Author Response to Interactive comment on “In situ continuous visible and near-infrared spectroscopy of an alpine snowpack” by Marie Dumont et al.

Anonymous Referee #2

Received and published: 8 January 2017

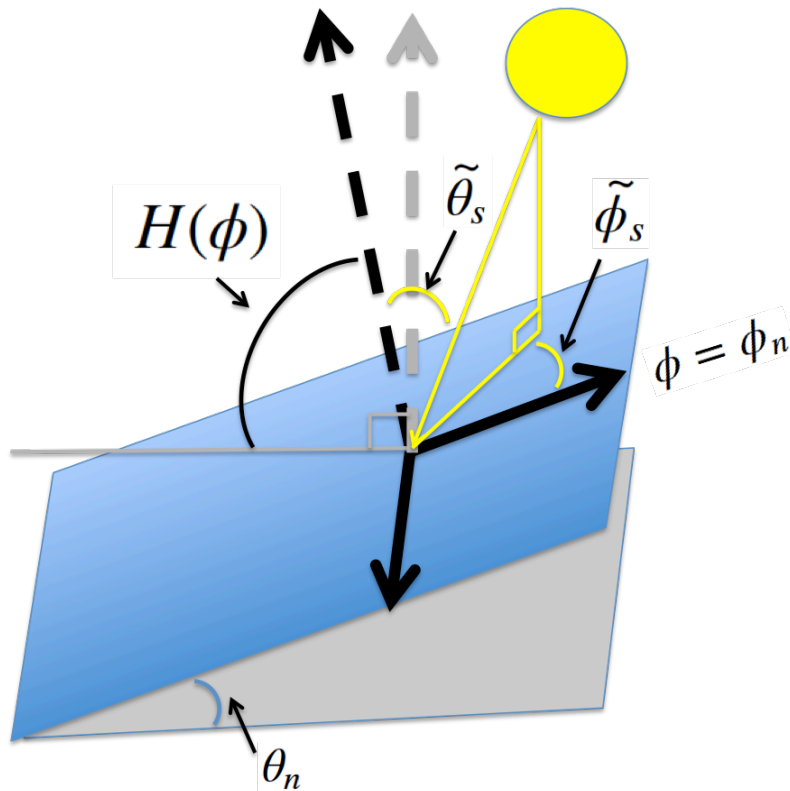
Sect. 3.3 is quite hard to follow. The equations to calculate the effect of slope on diffuse radiation and on measured albedo are presented in Appendices A and B, but without explaining many passages, so it is too laborious for me to check them, and it is difficult for an interested reader to apply them without a full understanding. The authors refer to some literature for the details (Dumont et al, 2011, Wang et al 2016), but they need to report in the paper the key concepts and passages to make the paper self-sufficient. For instance, what is the physical meaning of the parameter “K”? Probably also a schematic drawing of the angles of the tilted and horizontal surface would help to understand the equations.

The schematic drawing below has also been added in the paper so that equations in Appendices A and B can be understood more clearly.

“Figure 2. Schematic drawing of the tilted snow surface (blue plane) and associated angles. The grey plane corresponds to the horizontal plane. The black reference frame is the one attached to the tilted surface. The grey arrow represents the vertical with respect to the horizontal plane. $H(\Phi)$ is the horizon line in the tilted reference frame. $\tilde{\theta}_s$ and $\tilde{\phi}_s$ are the zenith and azimuth sun angles in the tilted reference frame. θ_n is the slope elevation and Φ_n the aspect. “

References to this figure has been added page 7 line 2 and page 15 line 3.
